DC3300 Dust Collector Switch Update and Service Information

The following information pertains to all Shopsmith DC3300 Dust Collectors, If you are repairing a Dust Collector with has a Date Code of 10/14/92 or later, please refer to items 1 & 2 below. If you are repairing a Dust Collector, which contains a Date Code earlier than 10/14/92, please refer to Item #2 below.

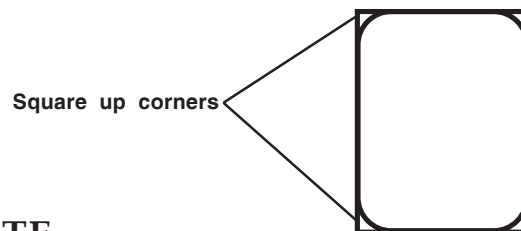
2. The following Parts/Part Numbers have changed. Please update your Dust Collector Instruction Manual.

It may be necessary to slightly modify the switch opening to allow the new Switch to be inserted in place. Use a metal file to square up the corners of the switch opening as shown.
